PRIVATE STORM WATER SEWER EXTENSION

WICHITA PUBLIC SCHOOLS (BLDG. 360)

RIVERSIDE ELEMENTARY SCHOOL

As-Built Plans

SWS LINE NO. 1
PLAN AND PROFILE

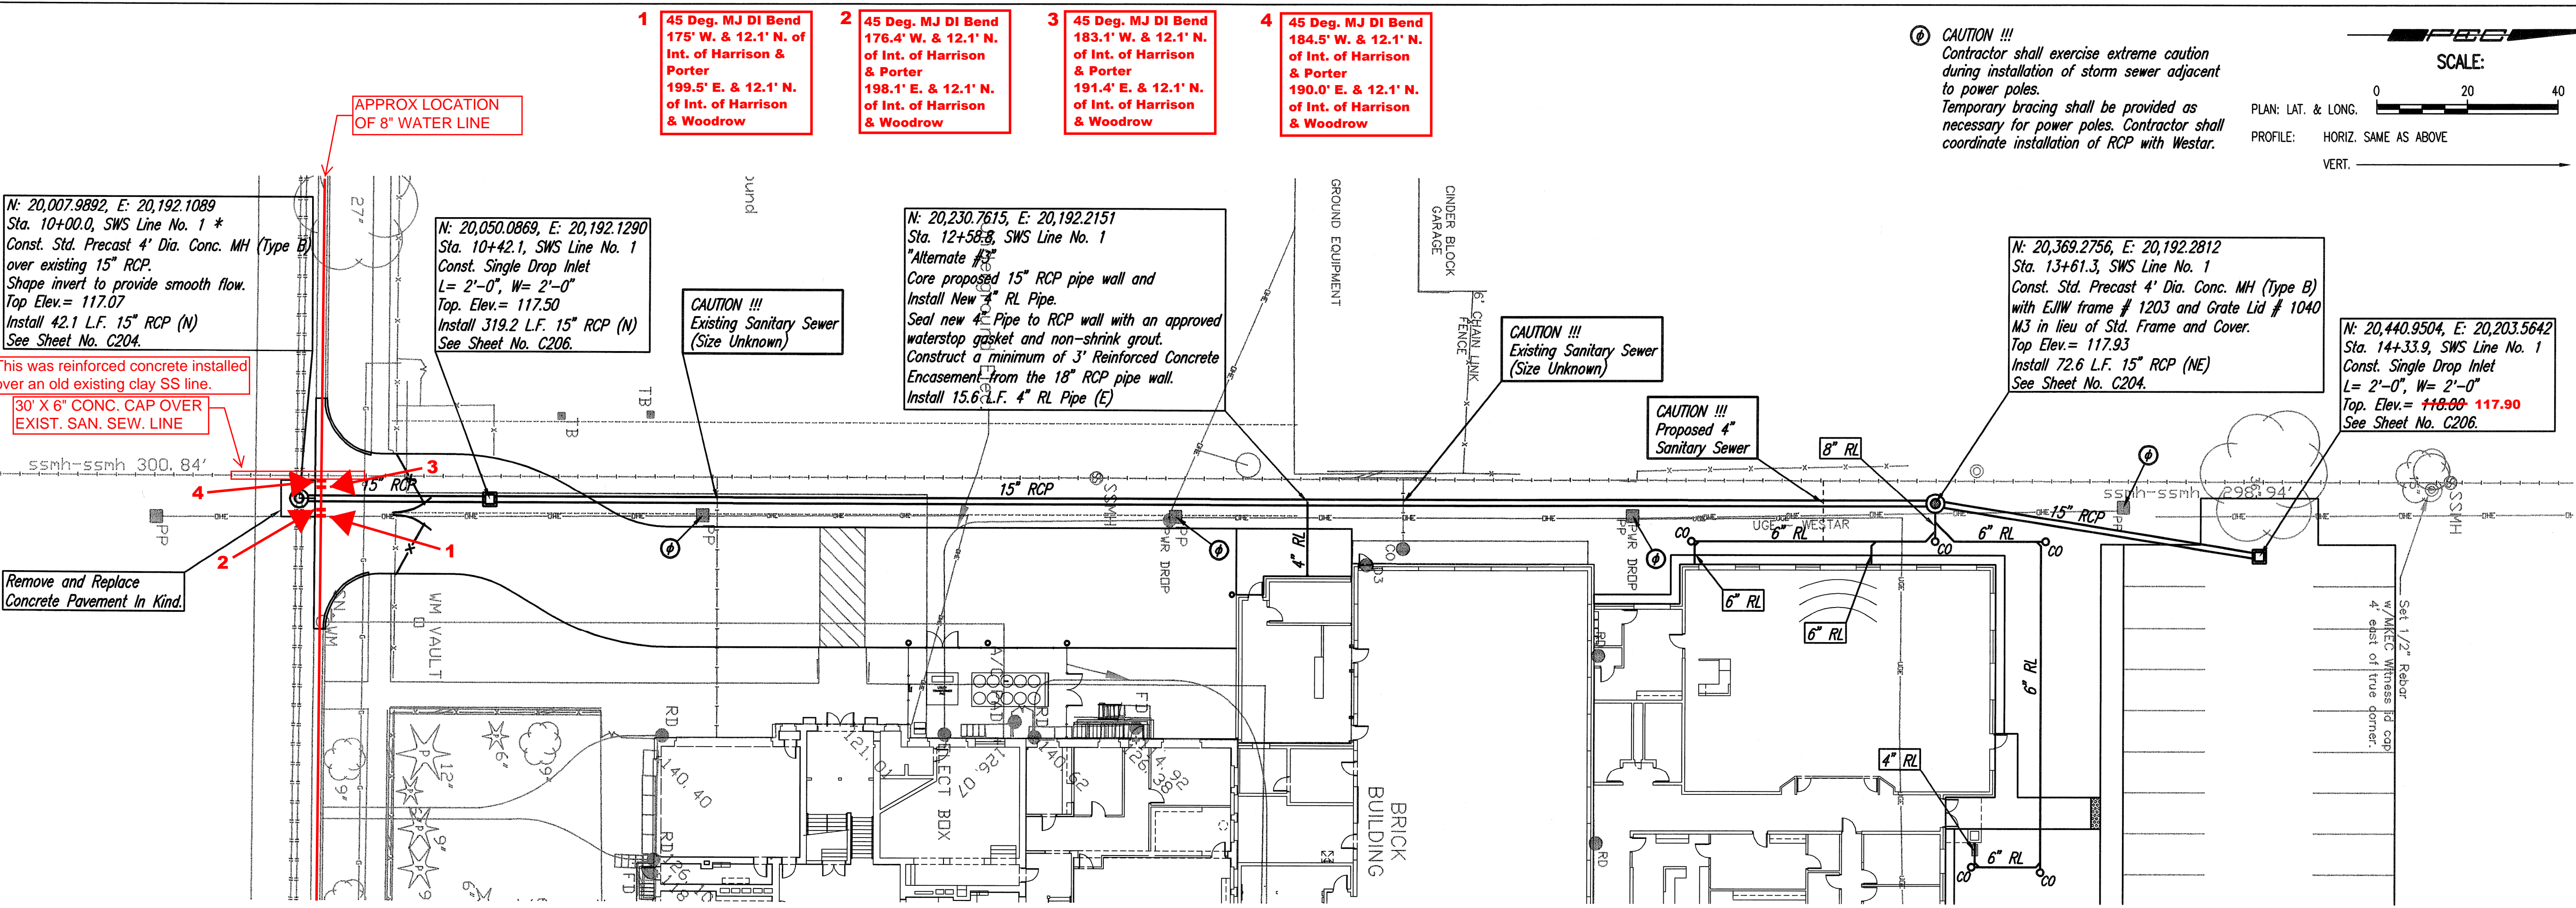
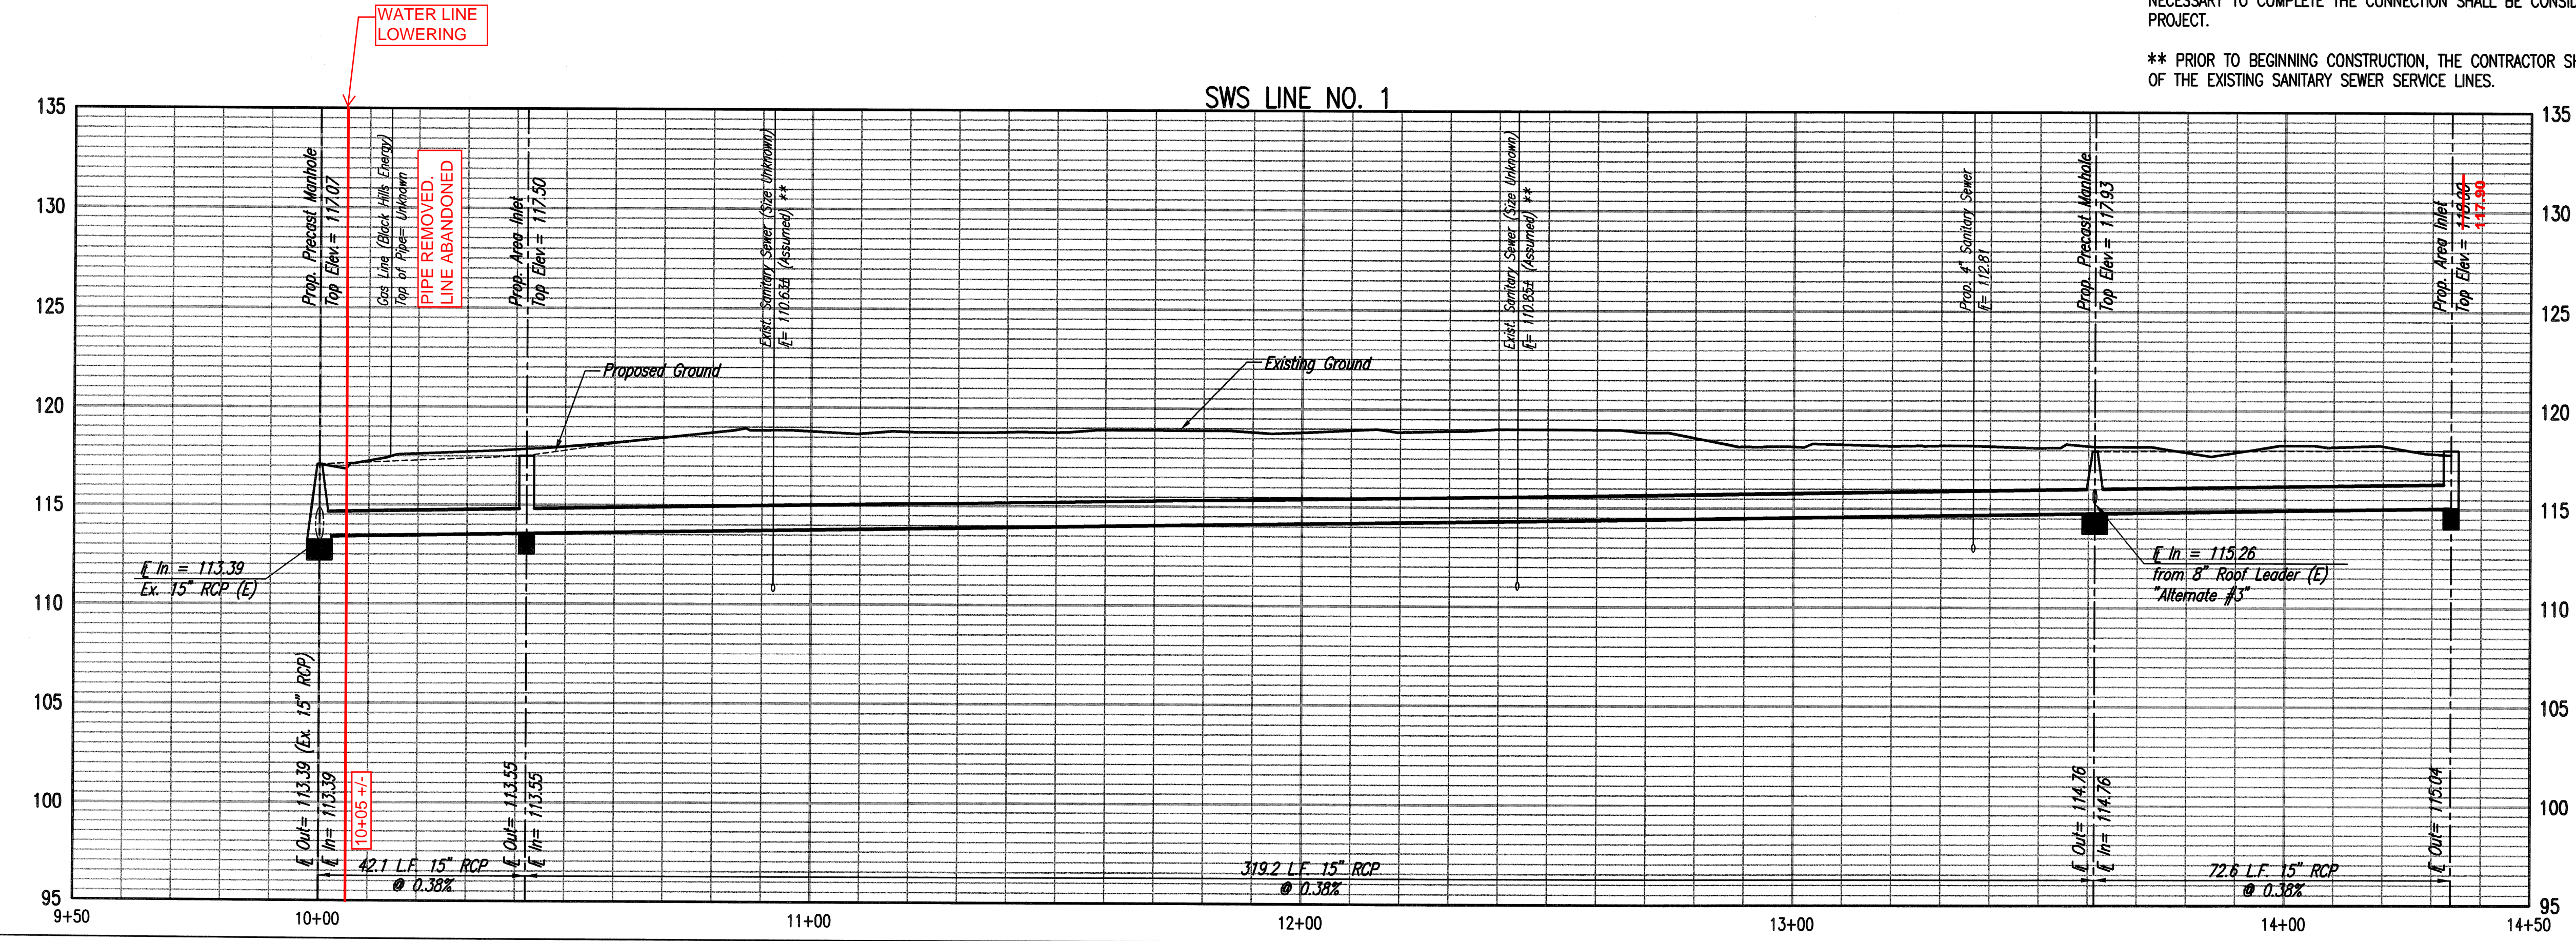
N: 20,440.9504, E: 20,203.5642
Sta. 14+33.9, SWS Line No. 1
Const. Single Drop Inlet
L= 2'-0", W= 2'-0"
Top. Elev. = ~~118.00~~ 117.90
See Sheet No. C206.

This was reinforced concrete installed
over an old existing clay SS line.
30' X 6" CONC. CAP OVER
EXIST. SAN. SEW. LINE
